South Texas Project Electric Generating Station P.O. Box 289 Wadsworth, Texas 77483

December 10, 2003
NOC-AE-03001645
STI: 31679561
FILE NO: Z18
ER 20030053
10CFR50.4(b)(5)
10CFR50 App E

Docket Nos. STN 50-498; STN 50-499
Changes to Emergency Plan Procedures

In accordance with 10CFR50.4(b)(5) and 10CFR50, Appendix E, Section V, the STP Nuclear Operating Company hereby submits the attached Emergency Plan and Implementing Procedure revisions.

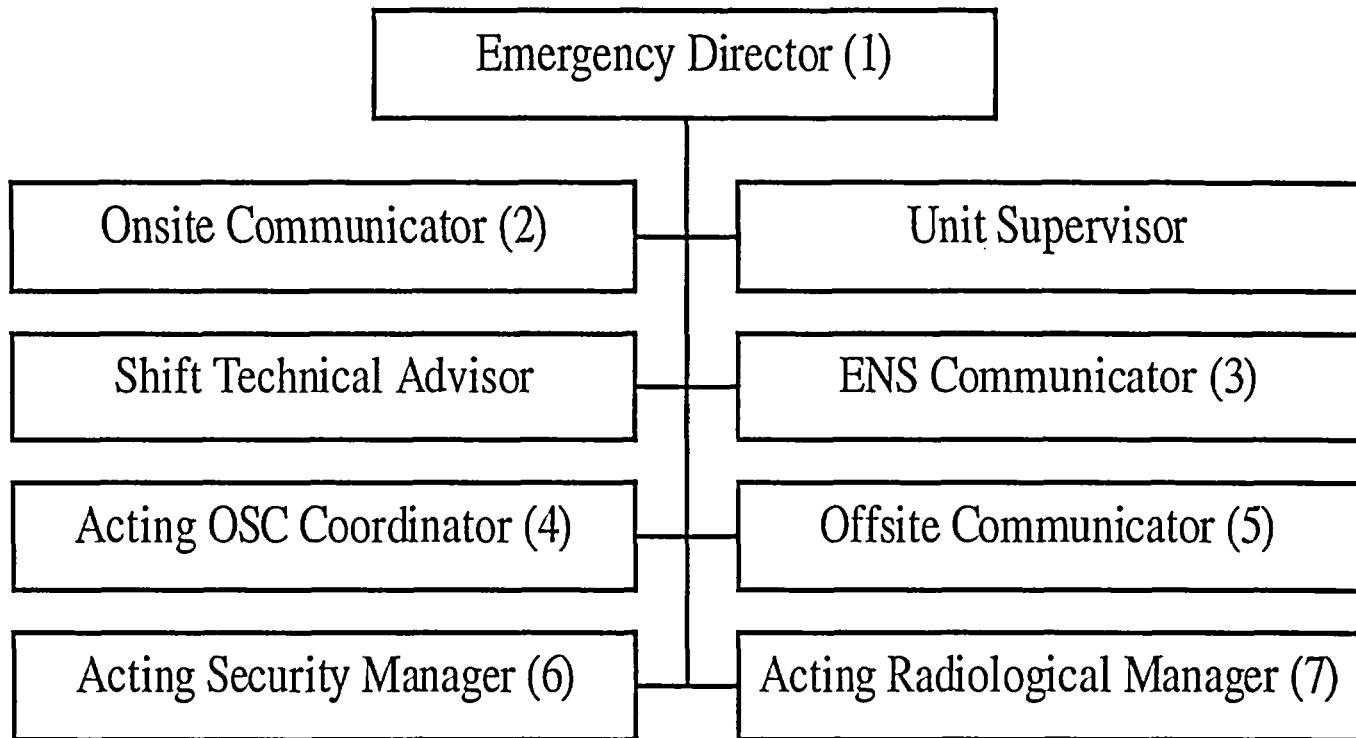
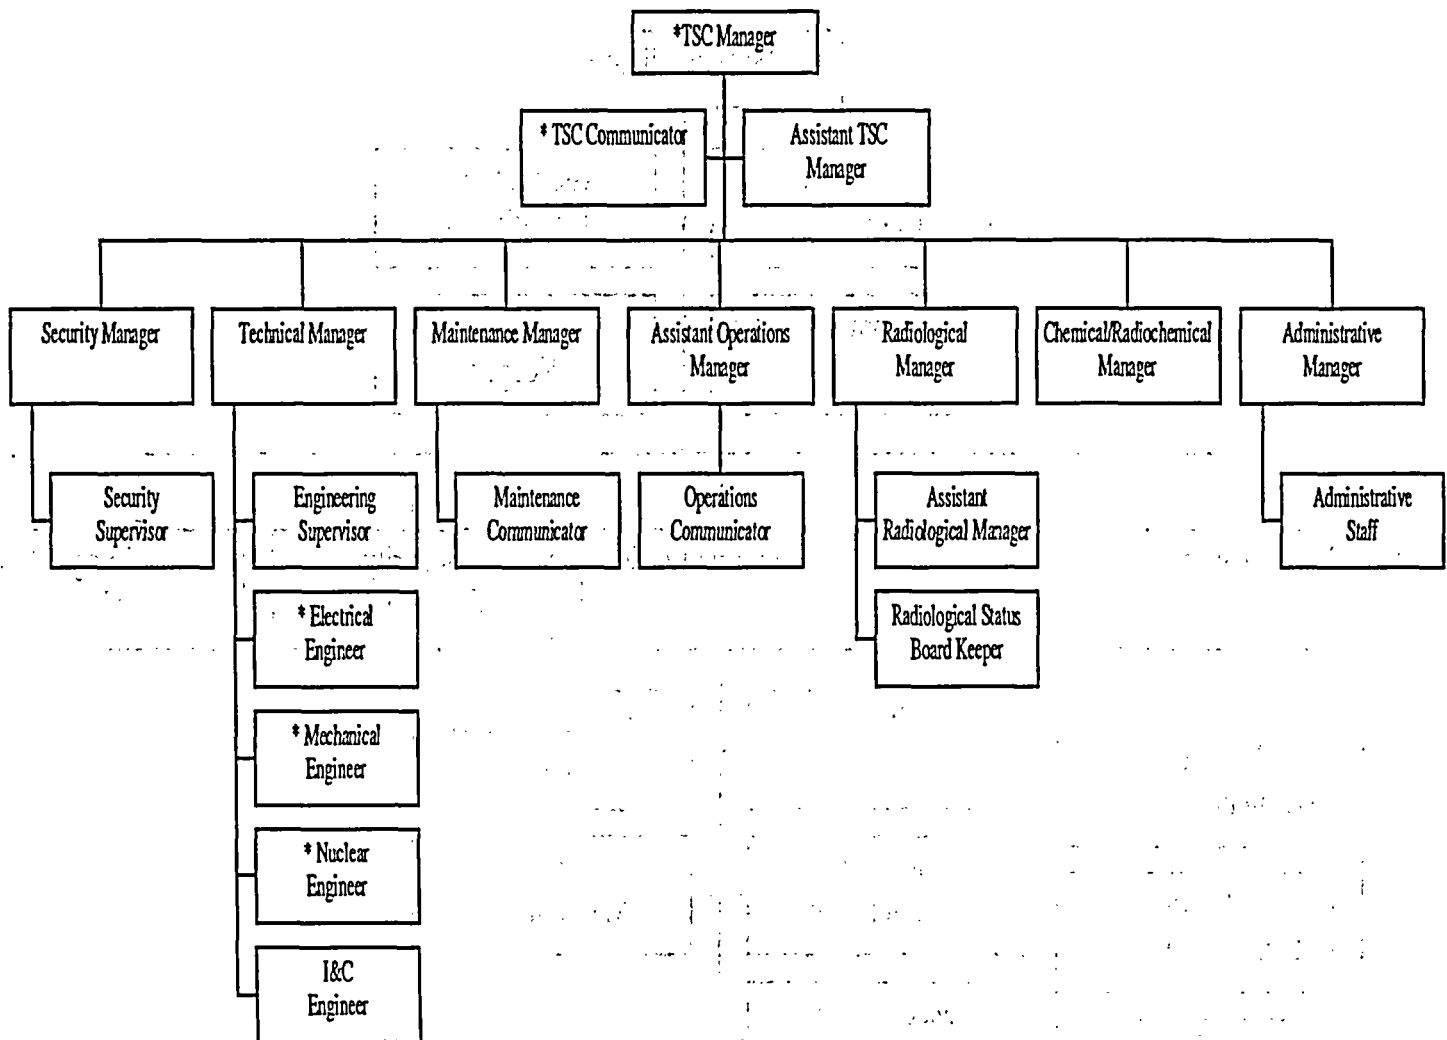
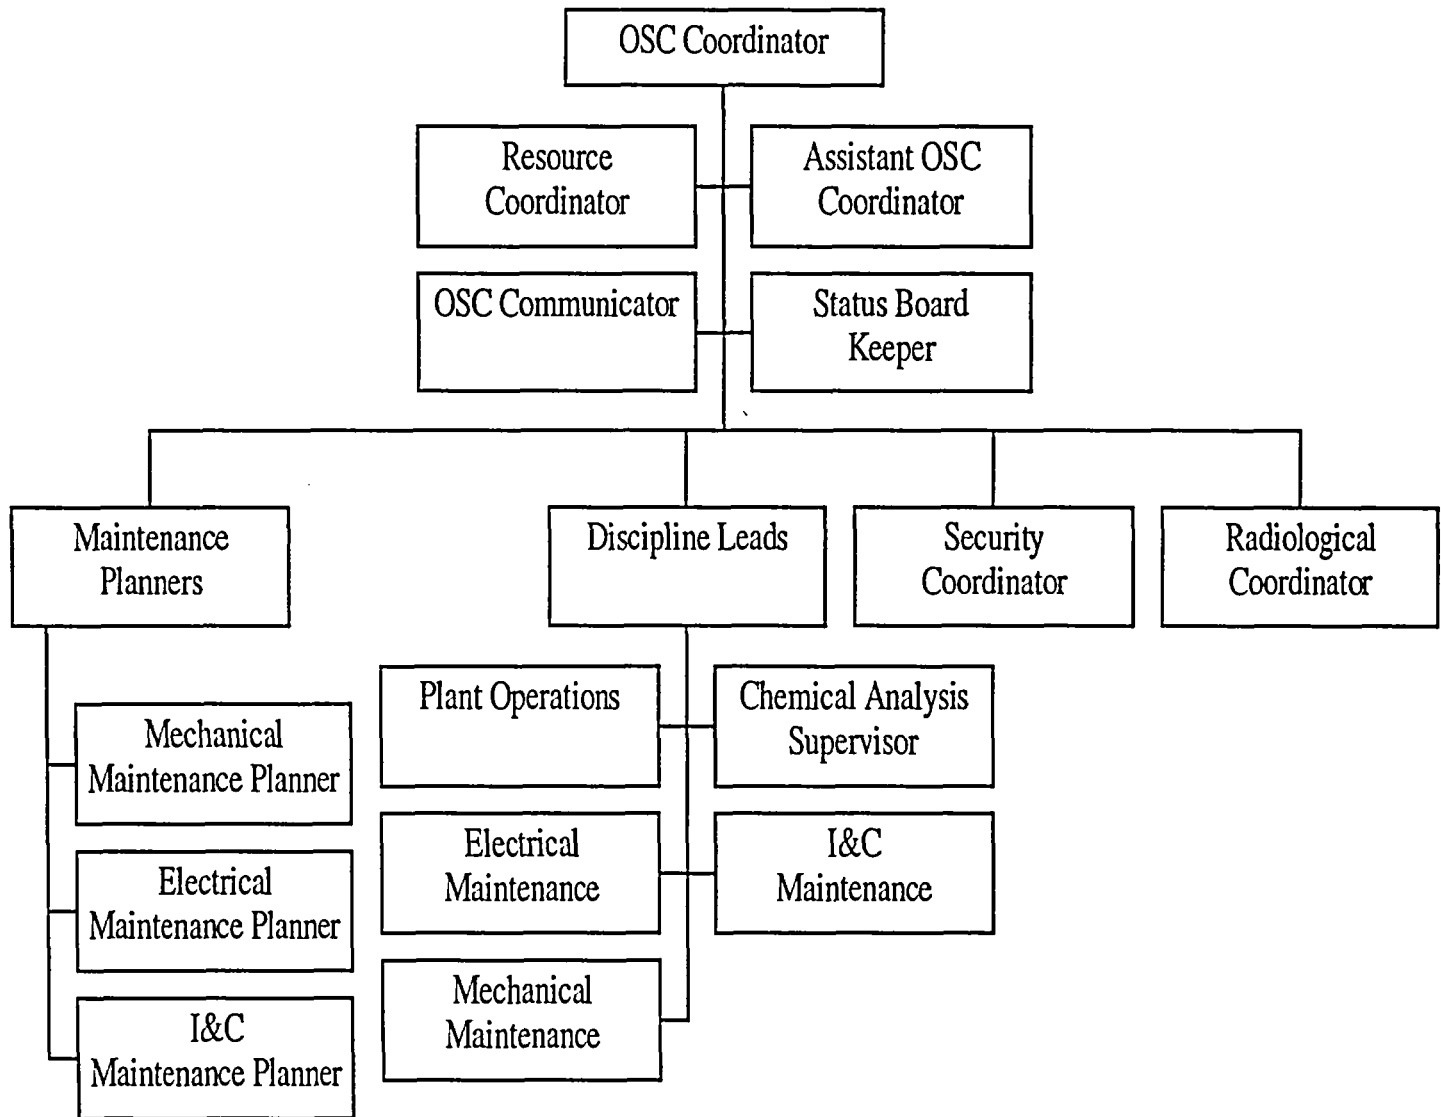
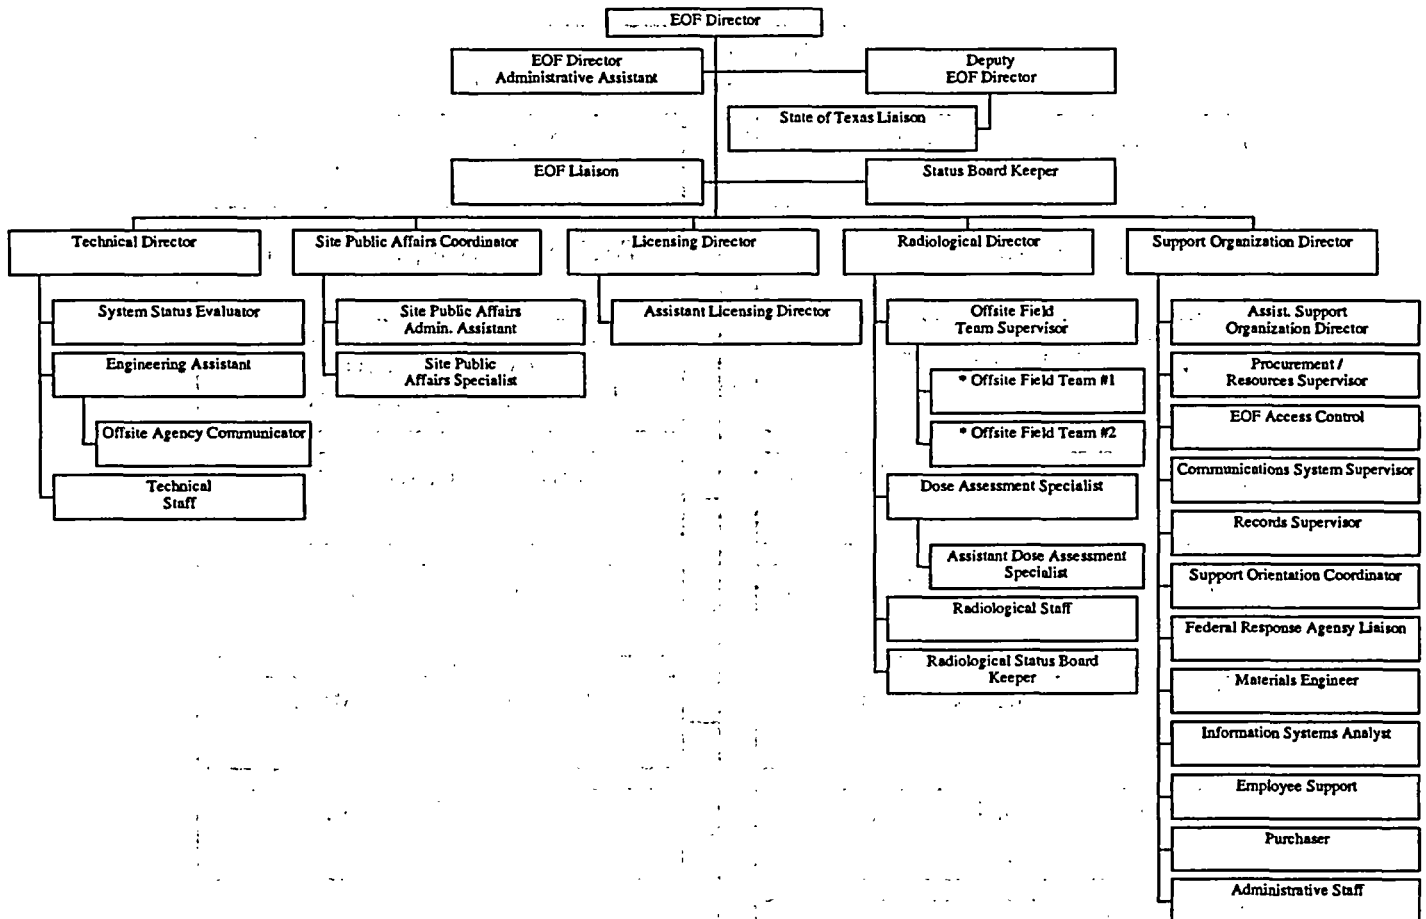
NO	CHANGE	REASON
7	Section C, Figure C-1 through C-4, pages 16-19, revised to look like staffing boards in the facilities	Editorial Clarification, no title changes
8	Section C, Figure C-5, page 20, renamed one of admin staff Communications Technician in the JIC	Clarification, individuals were already part of the Staff
9	Section E, step E.3, page 4, Added not to exceed four months	Missing Appendix E requirement
10	Section E, Figure E-1, Siren Locations	Changed siren IDs from letter to number codes.
11	Section E, New Figure E-3, Added titles for those in charge at both ends of communication links	Missing Appendix E requirement
12	Section G, step G.7, page 6, changes State Emergency Operations Center to State Operations Center	Editorial, Facility name change
13	Section G, step G.11, page 8, Added location of first aid station	Missing Appendix E requirement
14	Section I, page 4, revised 10-mile EPZ Map	Road # typo

0ERP01-ZV-OF02	Rev. 5	Page 24 of 25
Joint Information Center Activation, Operation, and Deactivation			
Addendum 4	Joint Information Center Floor Plan (Sample)	Page 7 of 7

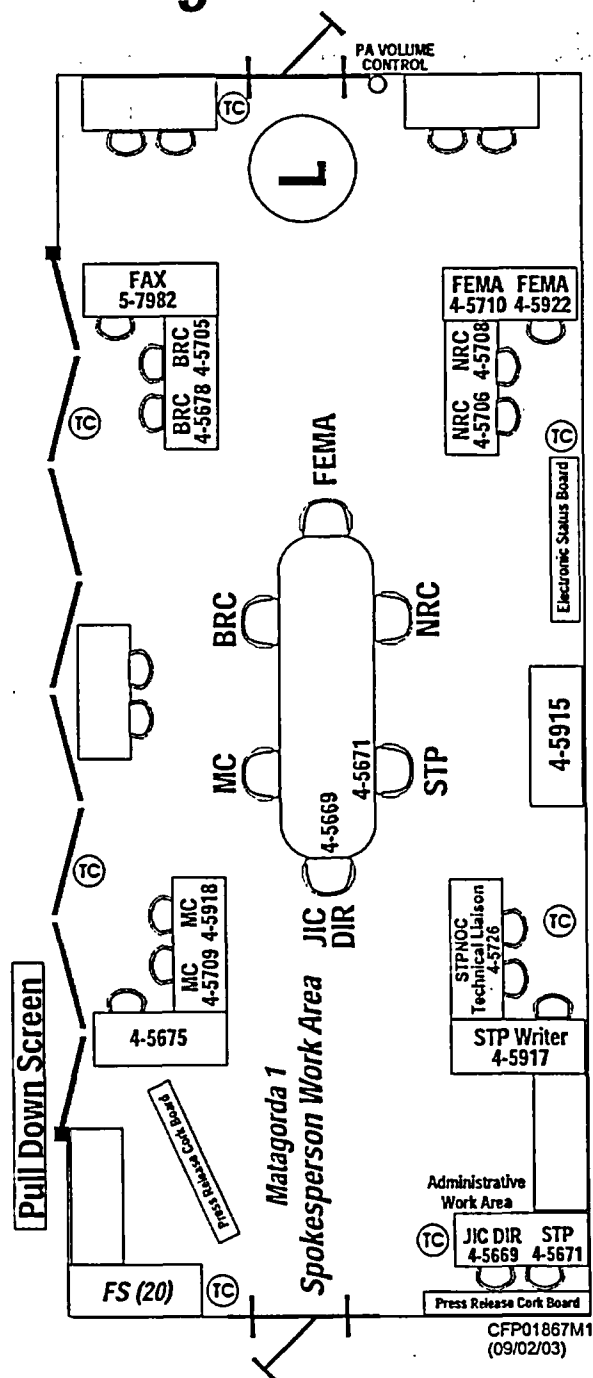
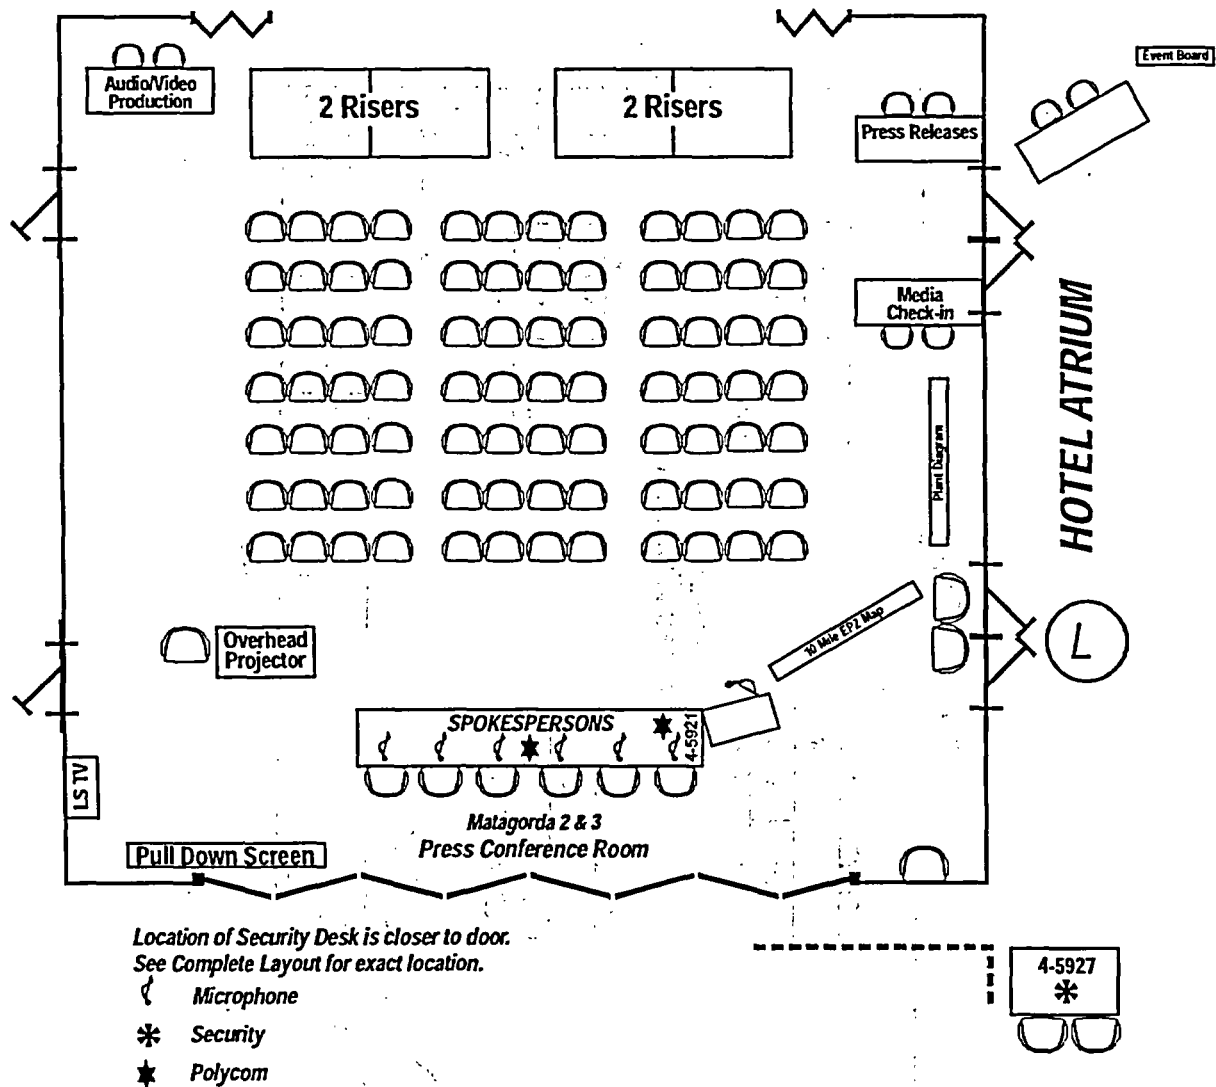
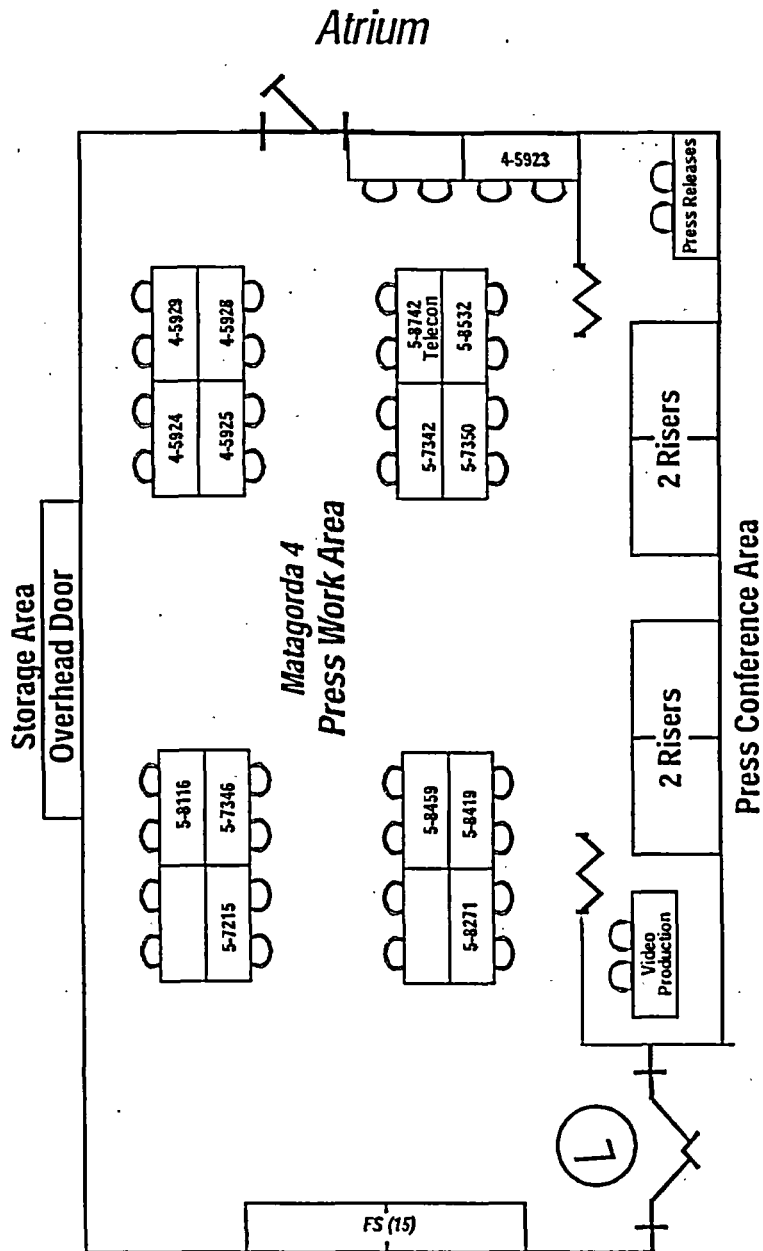
NO	CHANGE	REASON
18	Addendum 4, made minor changes to JIC layout drawings – removed most telephones from the center table in the Spokesperson Work Area room, added additional isles in the Press Conference room and deleted several rows of chairs and added Polycom, changed name of Rumor Control in Public Inquiry room to Public Inquiry, added teleconference to phone in Media Work Area that can be used for initial teleconference.	To reflect minor changes team has decided to make to the set up of the facility.
19	Added Addendum 5, JIC Priority set up.	During a drill, the team requested a JIC facility priority set up be provided in the procedure.
